**Re: Response to EPA Analysis of the *Final Habitat Mitigation and Monitoring Plan*, dated September 12, 2017, EPA Comments October 5, 2017 (Revised November 30, 2017)
Rosemont Copper Project, Clean Water Act Section 404 Permit, CoE File No.: 2008-00816-MB**

RESPONSE TO ENVIRONMENTAL PROTECTION AGENCY (2017)

**"The Mitigation Proposed by Rosemont Mine
Will Not Offset Impacts to Waters of the U.S.
below the Level of Significant Degradation"**

Project Number: 1049.117
January 24, 2018

Exhibit 6. Three (3) Year Total Annual Precipitation Variability across the Rosemont Project Watershed

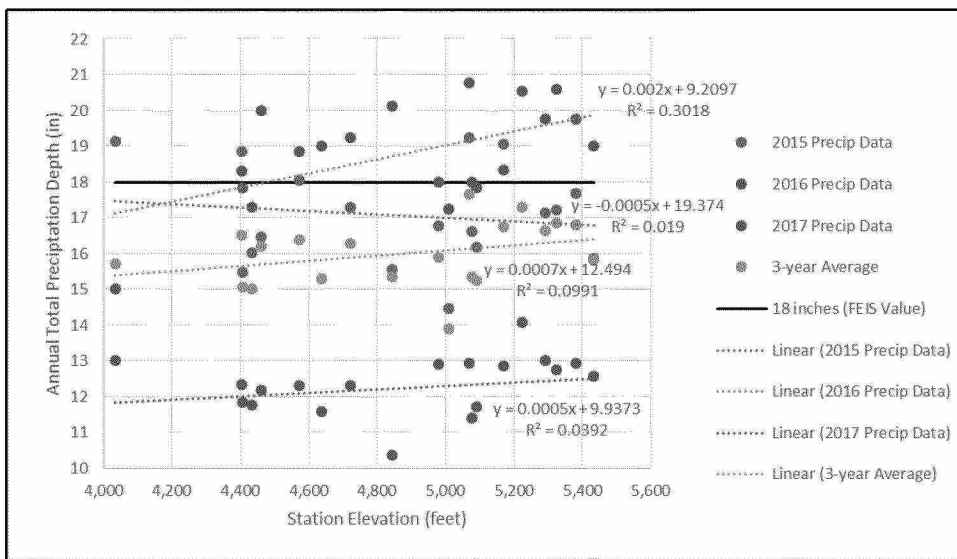
The EPA (2017) also provides the following comment with regard to precipitation across the site: *“The model parameterization for average annual rainfall (i.e., 18 inches) in Equation 2 is likely significantly less than values at the higher-elevation stock pond locations.”* Here, the EPA is alluding to a presumed relationship between elevation and precipitation at the Rosemont Project, where higher elevation theoretically equates to higher precipitation. While that orographic relationship may exist on a regional scale, it is less evident on a smaller watershed scale, such as for the Rosemont Project where the watershed is a maximum of 5.5 miles wide (measured from the southwest corner of Wasp Canyon sub-watershed to the USGS SR 83 streamgage).

Exhibit 6 shows the total annual rainfall (recorded at each of the 21 gages) plotted against the gage elevation. Best fit linear regression trend lines (and equations) are also plotted. Although there are only three years of data available (from May 2015 through December 2017), four important conclusions can be made: (1) there is a high year-to-year variability in total annual precipitation (e.g., in 2016 the total average precipitation throughout the site was about 18.8 inches, but only 12.2 inches in 2017); (2) there does not appear to be any meaningful relationship showing an increase in total annual precipitation with elevation (e.g., R^2 values are all less than 0.3, which indicate that the linear regression equations do not

represent any meaningful relationship); (3) there is high variability in total annual precipitation across the watershed (e.g., in several cases, gages at lower elevations had higher precipitation values than gages at higher elevations); and (4) the average value of 18 inches (used in the FEIS) is representative, and likely a conservative estimate, for the site-wide average. Thus, the average-annual rainfall value of 18 inches is valid and representative for the entire Rosemont Project watershed.
